Mount Jefferson Park Site Plan

Update for the Park and Recreation Commission

MOUNT JEFFERSON PARK IMPROVEMENTS
PRELIMINARY DSP
City of Alexandria, VA Stonebridge Center
OVERALL SITE PLAN

May 21, 2015

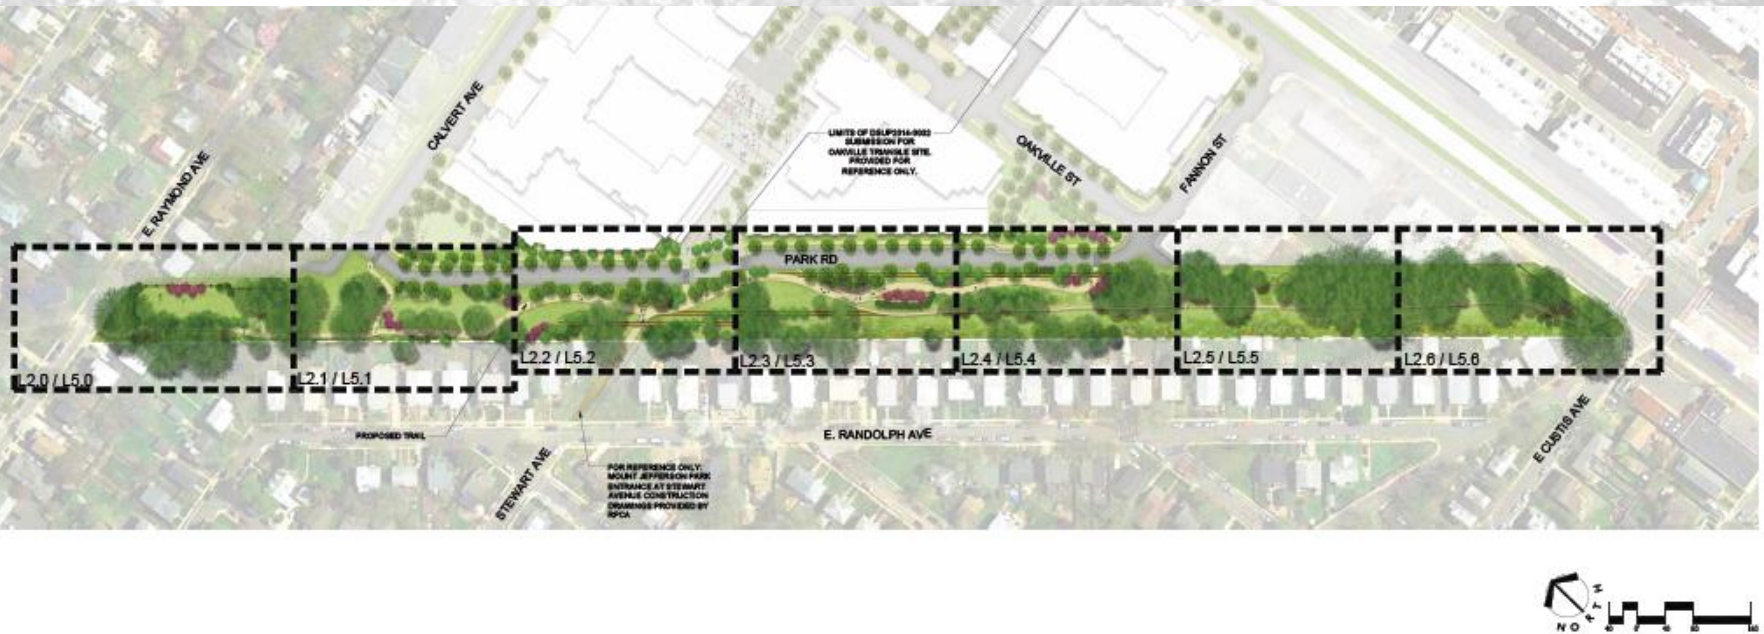
PRC endorsed the Concept Plan, asking staff to consider the following items in the site plan :

- * Community desire to maintain natural forested areas and wildlife;
- * Street trees along the new Park Road should not be planted/designed in a straight line;
- * Include evergreen trees in the berm and buffer plantings; and
- * Leave half the trail permeable, and the other half as it is today along the highest part of the railway berm.

- * Developed in coordination with the Division of Natural Resources and includes all native plants and trees appropriate to the area and wildlife;
- * Provides clustered street trees with additional low level plantings along the park side of Park Road;
- * Includes 3' high berms and buffer areas planted with different types of evergreens;
- * Minimizes impact on existing trees; and
- * New pervious trail surfacing between East Raymond Avenue and the midway point of the park and the secondary trail connection areas only.

- * Includes an engineered stormwater/drainage and grading plan to address ponding issues;
- * Incorporates interpretive elements based on Mount Jefferson Park's history and character; and
- * Shows the potential future trail extension at grade to Route 1.
